**REQUEST FOR INFORMATION
FOR
COUNTY OF SAN MATEO**

**BROADMOOR SAFE ROUTES TO SCHOOLS PEDESTRIAN IMPROVEMENTS
PROJECT**

**COUNTY PROJECT NO. RW940
PROJECT FILE NO. E5050
FEDERAL-AID PROJECT NO. STPL-5935(087)**

**THE COUNTY OF SAN MATEO DEPARTMENT OF PUBLIC WORKS
HAS PROVIDED RESPONSES (R) TO THE QUESTIONS (Q) BELOW**

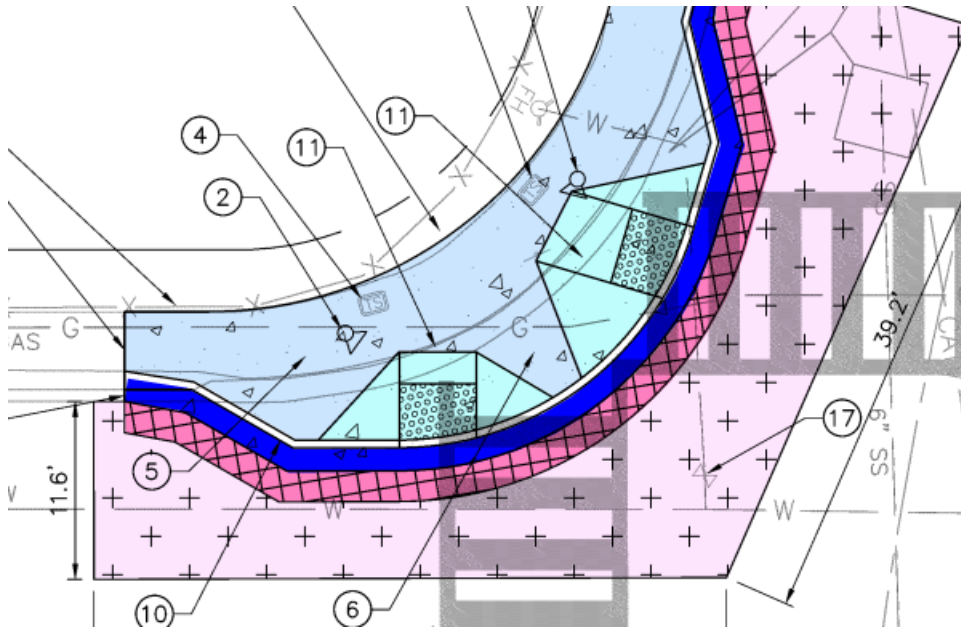
- Q7. The specs mention for ac plug to be paid under the concrete class 3 item and mentioned ¾" AC but there is a bid item for ½" asphalt (15 tons). Can you please confirm that the asphalt along the curb and gutter (see dark pink area below) that is shown on the plans is ½" AC and will be paid for under bid item #18?

- R7.** *No, the asphalt used for temporary AC plug for the construction of concrete curb and gutter and conform to the existing road shall be included in bid item #22 for Class 3 Concrete. The temporary AC plug section shall be 3" AC over 9" Class 2 AB. The 9" Class 2 AB will be paid for under bid item #15. The top portion of the temporary AC plug shall be removed during the grind and overlay 3" asphalt paving operations.*
